Doc Ref: WI427-04F02(rev1)- Wind Environment Addendum Letter.docx

RE: 106 AND 120-122 SMITH STREET, AND 3A CHARLOTTE STREET, WOLLONGONG
"DESKTOP" WIND ENVIRONMENT ADDENDUM LETTER

Figure 1: Recommended Treatments - Ground Level

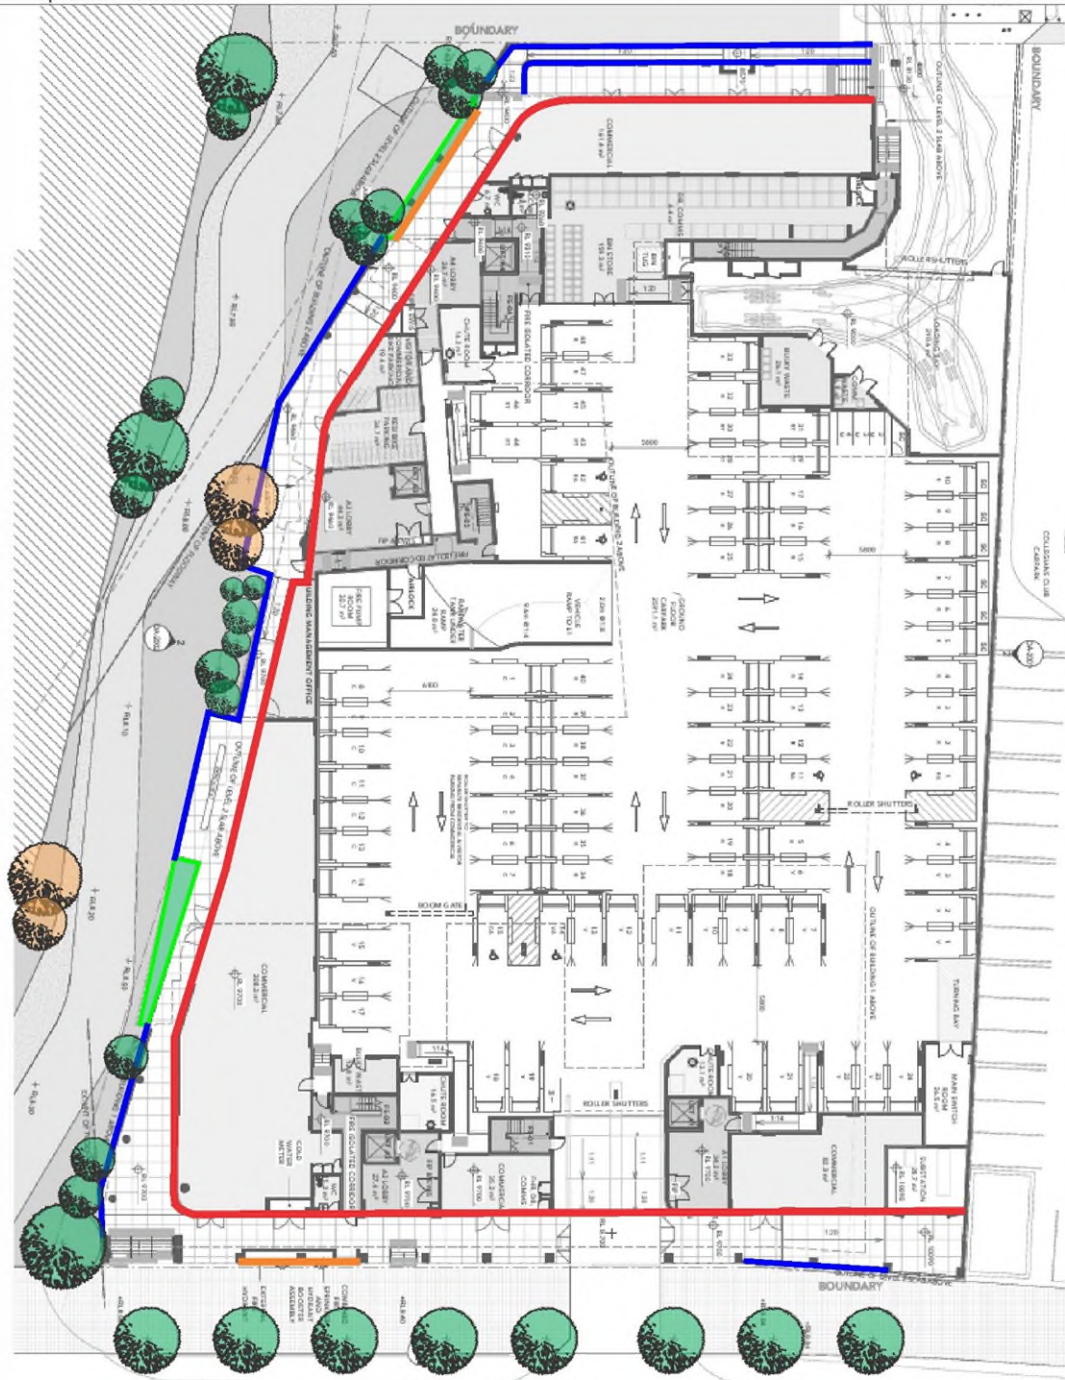
- Ground level trafficable areas:
 - Retention of the proposed 1.2m high porous balustrades along the northern, southern and western aspects of the development (ensuring that the maximum porosity is 30-35%).

- Retention of the proposed full-height porous screens along the southern and western aspects of the development (ensuring that the maximum porosity is 30-35%).

- Inclusion of 1.2m high vegetation (e.g. hedges/shrubs) within the proposed planter boxes along the northern and western boundaries of the site.
 - Retention of dense evergreen tree planting, capable of growing to heights of 3-5m along the western and southern aspects.

- Inclusion of additional evergreen tree planting, capable of growing to heights of 3-5m along the western aspect.
- Level 2 Podium:
 - Retention of the proposed 1.2m high impermeable balustrade around the various terraces.
